# SAN FRANCISCO PLANNING DEPARTMENT

**DATE:** May 12, 2010  
**TO:** Linda Avery, Planning Commission Secretary  
**FROM:** Debra Dwyer, Planning Department Staff  
**RE:** 2005.1074E, 935-965 Market Street, CityPlace  
Response to Comments on Draft EIR and  
Final EIR Certification Hearing

**DATE:** May 12, 2010  
**TO:** Members of the Planning Commission  
**FROM:** Debra Dwyer, Environmental Planner  
**CC:** Linda Avery, Planning Commission Secretary  
**RE:** Case No. 2005.1074, 935-965 Market Street (CityPlace) Project

Planning Department Case Number: 2005.1074E  
State Clearinghouse Number: 2008102089

FIGURE II.6: PROPOSED GROUND FLOOR PLAN (REVISED)

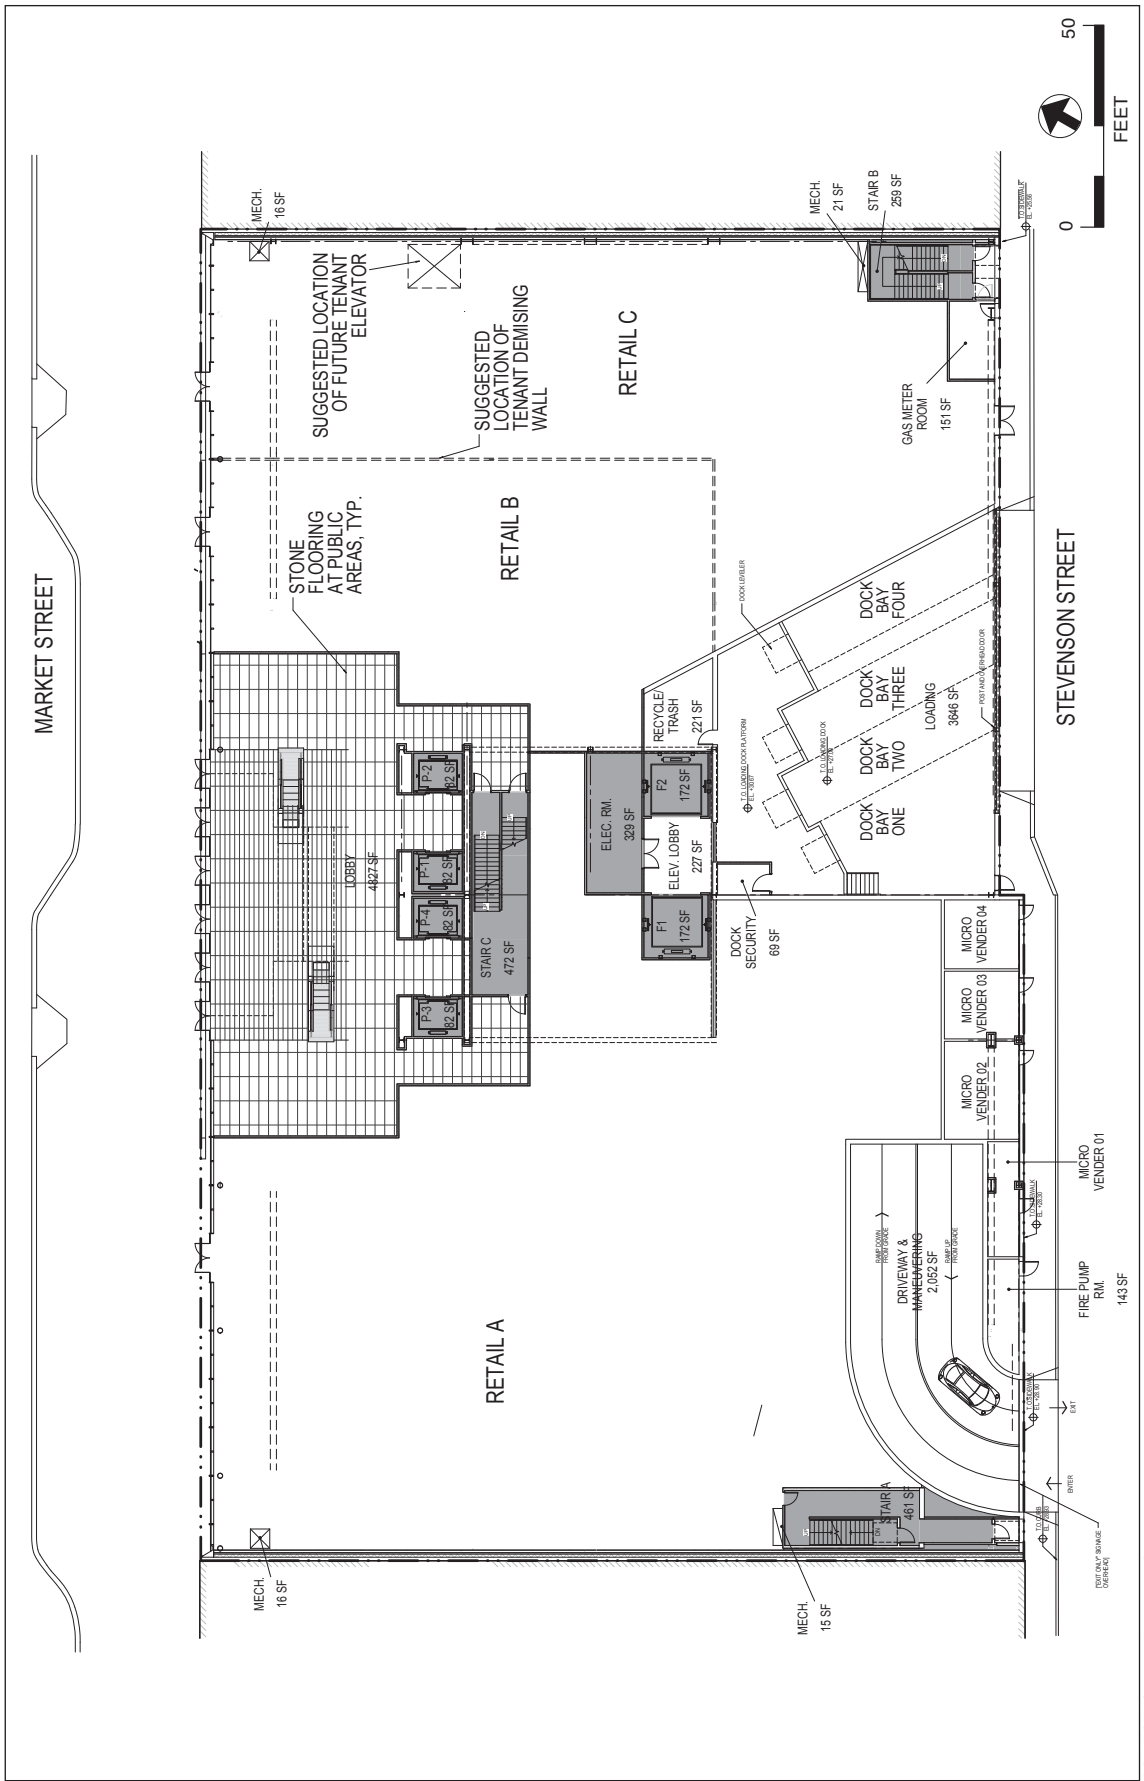
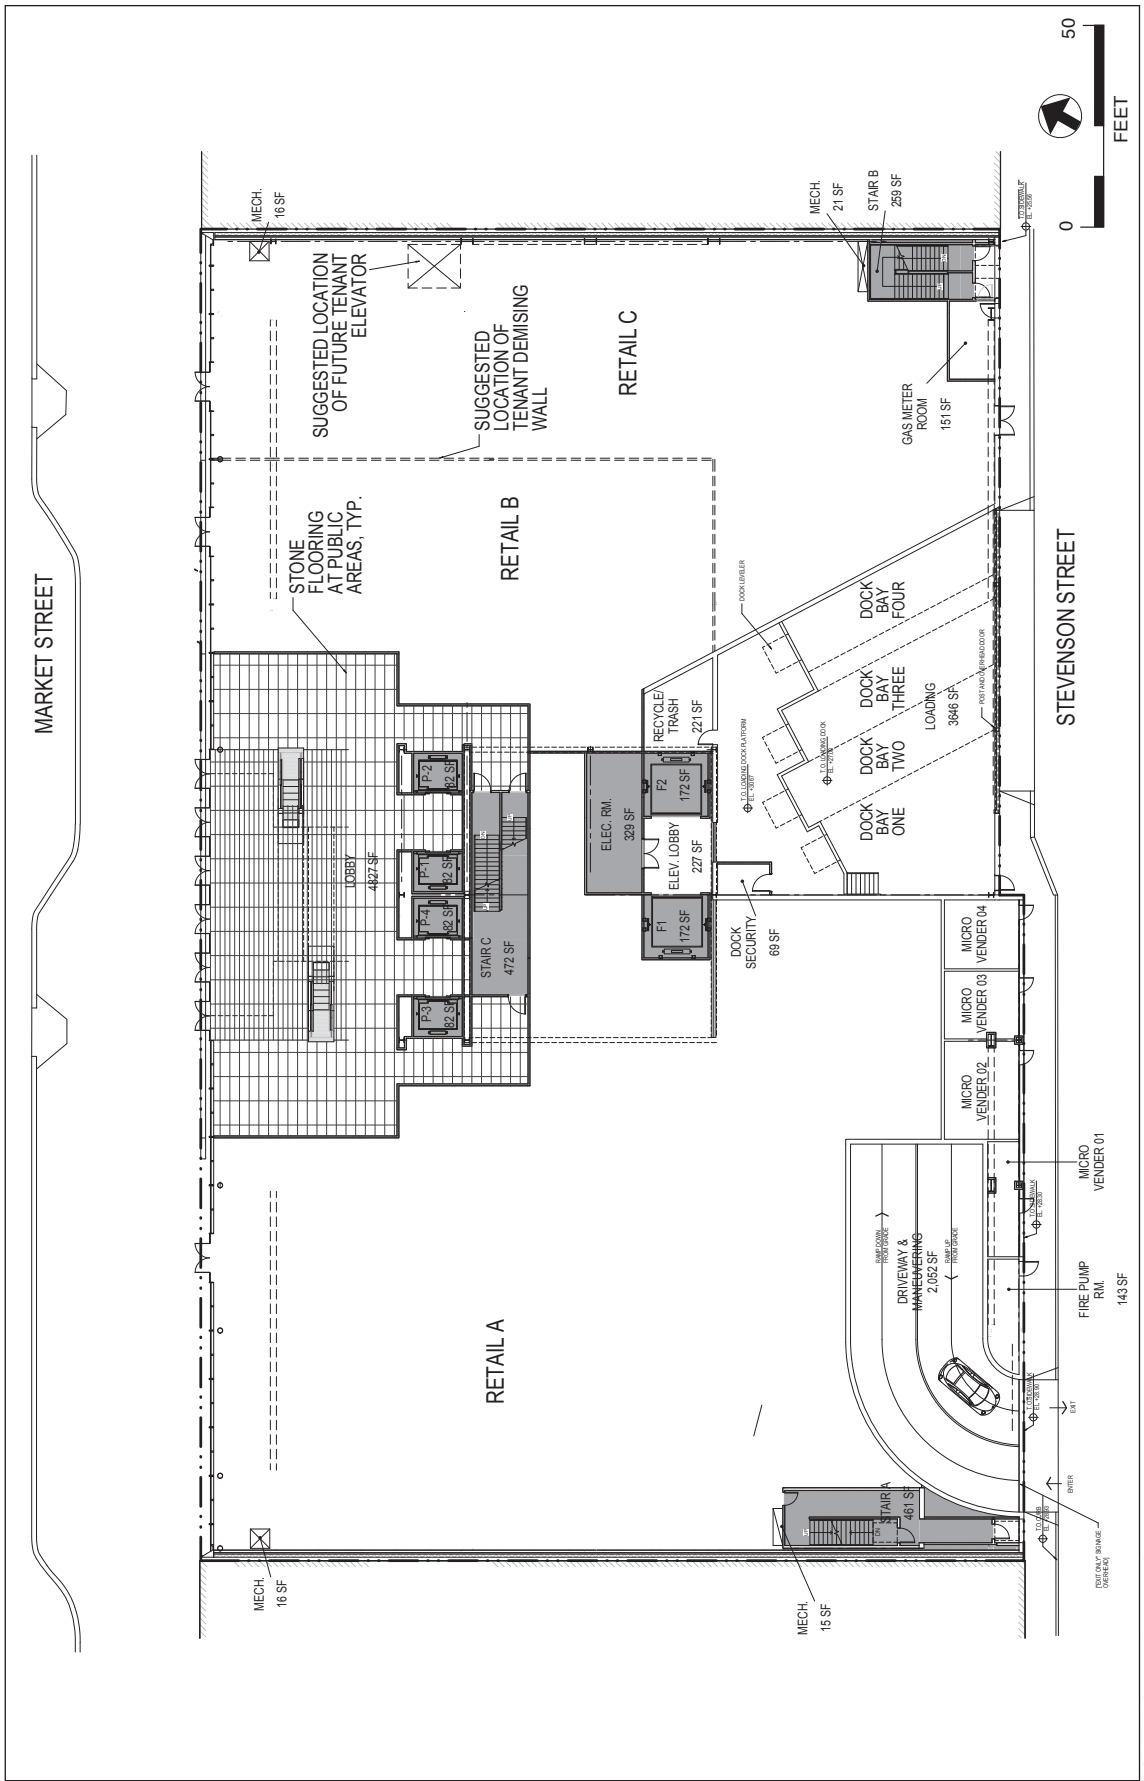
Regarding: Fig II.6: Proposed ground floor plan shows one driveway off of Stevenson Street with ingress and egress lanes (1 for each). Will the proposed project enforce a right-turn only for vehicles that are exiting from the parking structure onto the proposed Mitigation measure M-TR-1c? It will cause traffic congestion if vehicles exiting the garage are allowed to make left hand turns onto Stevenson Street while vehicles are attempting to enter the garage from Stevenson Street.” (Laura Kennedy, December 7, 2009) [G-2]

Regarding: Fig II.6 Proposed ground floor plan shows one driveway off of Stevenson Street with ingress and egress lanes (1 for each). Will the proposed project enforce a right-turn only for vehicles that are exiting from the parking structure onto the proposed Mitigation measure M-TR-1c? It will cause traffic congestion if vehicles exiting the garage are allowed to make left hand turns onto Stevenson Street while vehicles are attempting to enter the garage from Stevenson Street.

The commentor expressed concern with traffic queues from the proposed parking garage backing up into Stevenson Street and Sixth Street and the entry and exit lanes of the proposed parking garage as shown on Figure II.6.

With the proposed project, the garage driveways were configured so that the entry lane would be located to the west of the exit lane since Stevenson Street is one-way eastbound. With this layout, vehicles making a left-turn into the garage would not cross vehicles making a left-turn out of the garage. These EIR Figures, located on EIR pp. II.11, II.14, and II.17, have been revised for clarification to show the correct entry/exit sequence from one-way Stevenson Street and the correct parking space orientation at the second basement level. Please see Figure II.6: Proposed Ground Floor Plan (Revised), Figure II.8: Proposed First Basement Floor (B1) Plan (Revised), and Figure II.10: Proposed Second Basement Floor (B2) Plan (Revised) for the correct exit and entry and ramp directions/labels and the correct orientation for parking spaces at the second basement level.

As described on Draft EIR pp. IV.C.50-IV.C.51, proposed Mitigation Measure M-TR-1c would convert Stevenson Street, west of the proposed garage driveways, to two-way operation. SFMTA has reviewed Mitigation Measure M-TR-1c and determined that it would not be feasible. Therefore, as described on Draft EIR p. IV.C.51, M-TR-1c will not be implemented.

On EIR pp. II.11 and II.14, Figure II.6: Proposed Ground Floor Plan and Figure II.8: Proposed First Basement Floor (B1) Plan have been revised for clarification to show the correct entry/exit sequence from one-way Stevenson Street and the correct parking space orientation at the second basement level. These revised figures are presented below.
